**Replacement Stabilizer Bar Bushings –  
Lubricate Before Installing**

1997 MY-ON XK Range  
1998 MY-ON V8 XJ Series

ILLUSTRATION 1

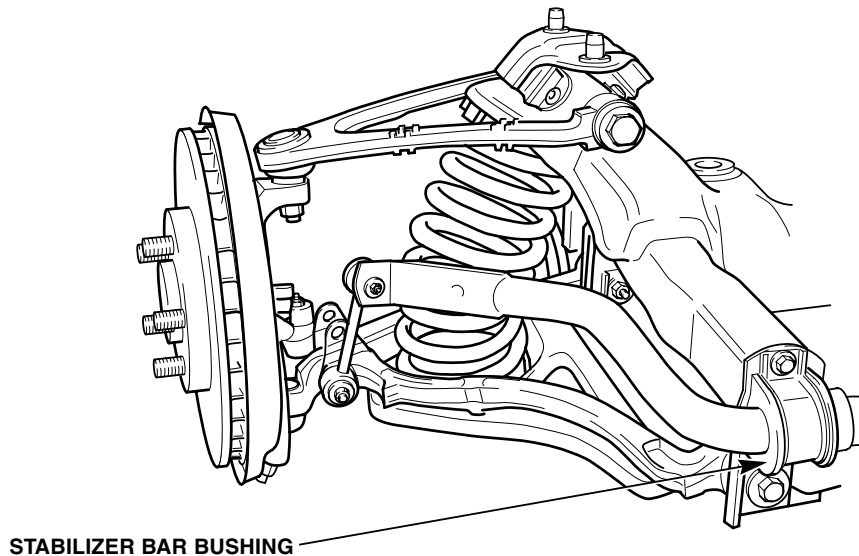
When replacing the front or rear stabilizer bar mounting bushings, apply Castrol NTR grease part no. 10558 to the inner face of the bushing. This action is required to allow free movement of the stabilizer bar within the bushings.

**⚠ Caution:** When applying the grease make sure that only the inner face of the bushings is coated with the grease. Grease applied to the outer face of the bushings will affect the retention of the bushing by the retaining brackets.
